SUBDIVISION REVIEW SHEET**CASE NO.:** C8-2016-0247.1A**P.C. DATE:** August 11, 2020**SUBDIVISION NAME:** Pioneer Crossing East Section 19 Final Plat**AREA:** 7.15 acres**LOTS:** 32**APPLICANT:** Continental Homes of Texas, LP
(Kevin Pape)**AGENT:** LJA Engineering, Inc.
(Justin D. Midura, P.E.)**ADDRESS OF SUBDIVISION:** Samsung Blvd. & 200-751 E. Braker Lane**WATERSHED:** Walnut Creek**COUNTY:** Travis**EXISTING ZONING:** P.U.D**JURISDICTION:** Full Purpose**PROPOSED LAND USE:** Residential**VARIANCE:** none**DEPARTMENT COMMENTS:**

CITY OF AUSTIN –DEVELOPMENT SERVICES DEPARTMENT
SUBDIVISION APPLICATION – MASTER COMMENT REPORT

PROJECT NAME: Pioneer Crossing East Section 19 Final Plat
LOCATION: 200-751 E BRAKER LN

Exhibit B: Proposed plat

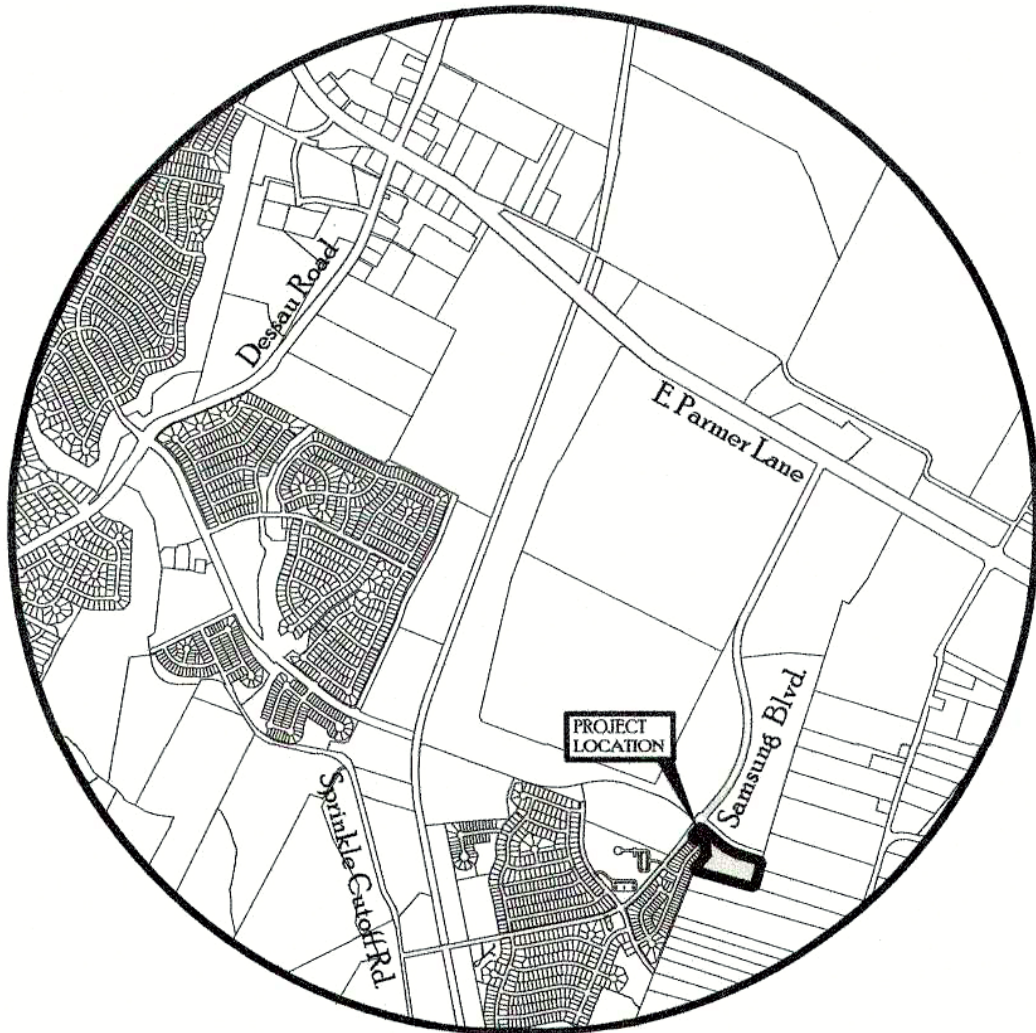
Staff recommends disapproval of the plat for the reasons listed in the comment report dated August 6, 2020, and attached as Exhibit C.

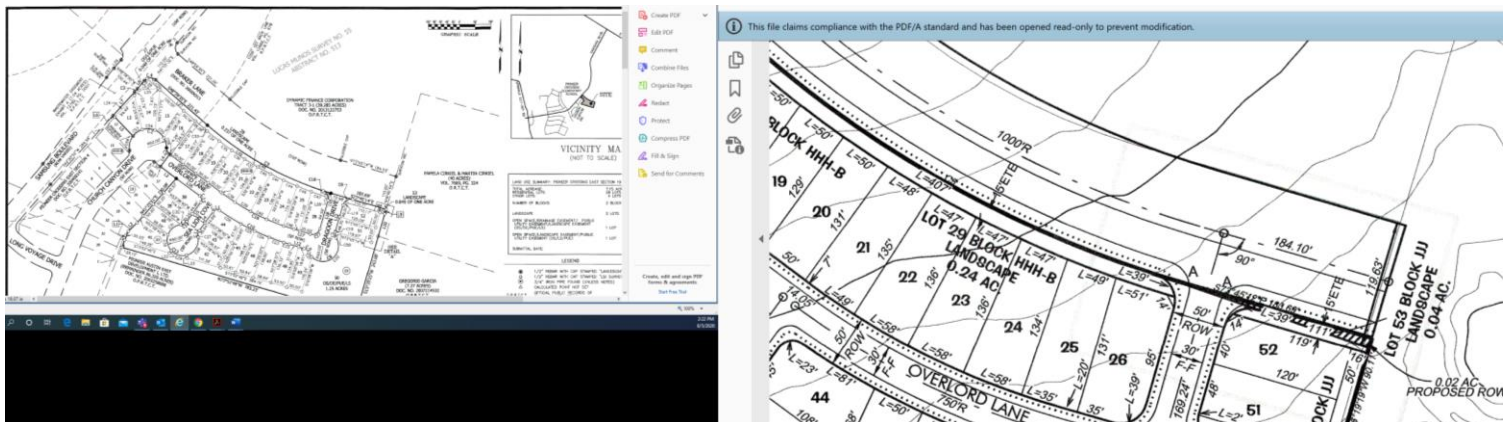
ATD 1. The proposed final plat does not appear to match the preliminary plan. In prior discussions regarding the preliminary plat, ATD and the applicant agreed upon the inclusion of a small sliver of additional right-of-way in order to accommodate the planned alignment of the Braker Lane extension. An additional .02 acres of right-of-way was added to the eastern end of Braker Lane right-of-way to terminate at 119.63' ROW width. Approved prelim. shown on the right below:
